UNITED STATES PATENT AND TRADEMARK OFFICE

Office Action Summary	Application No. 10/679,128	Applicant(s) LUMPKIN, WAYNE R.	
	Examiner William Windley III	Art Unit 3682

DETAILED ACTION

Fig. 3

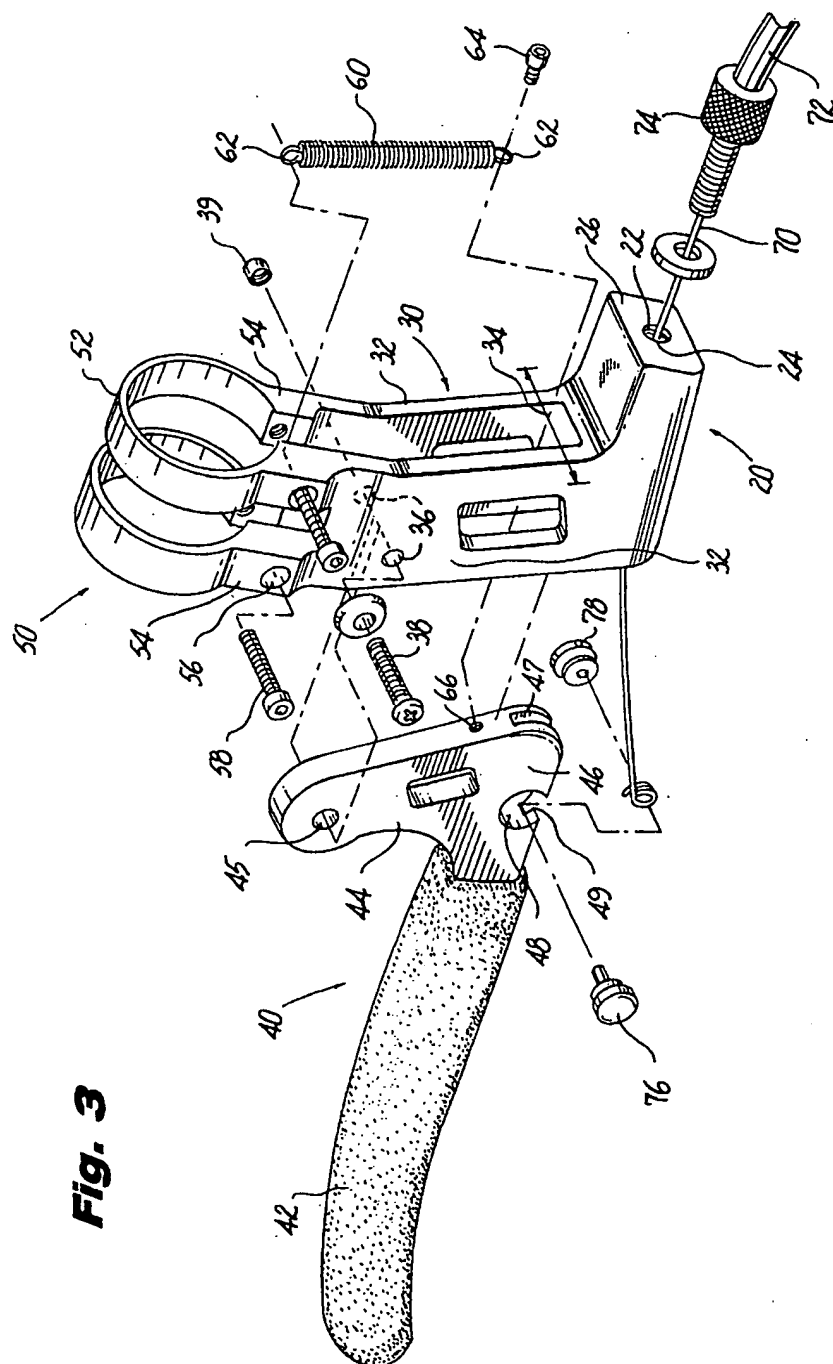
2. Claims 1, 4-10, and 11 are rejected under 35 U.S.C. 102(b) as being anticipated by Gelbein USP 5584210.

Gelbein discloses a(n):

- First arm (right side of 54)
- First threaded bore (right side of 56 on right side of 54)
- Second arm (left side of 54)
- Second threaded bore (left side of 56 on left side of 54)
- Screw (58)
- Head (100, See Figure 3 marked by examiner)
- Shank (110, See Figure 3 marked by examiner)
- Threaded portion (Threads toward the end of bolt 58)

- Clearance portion (Thread trough nearest the bolt head)
- Brake lever (40)
- Clamp (50)
- Housing (20)
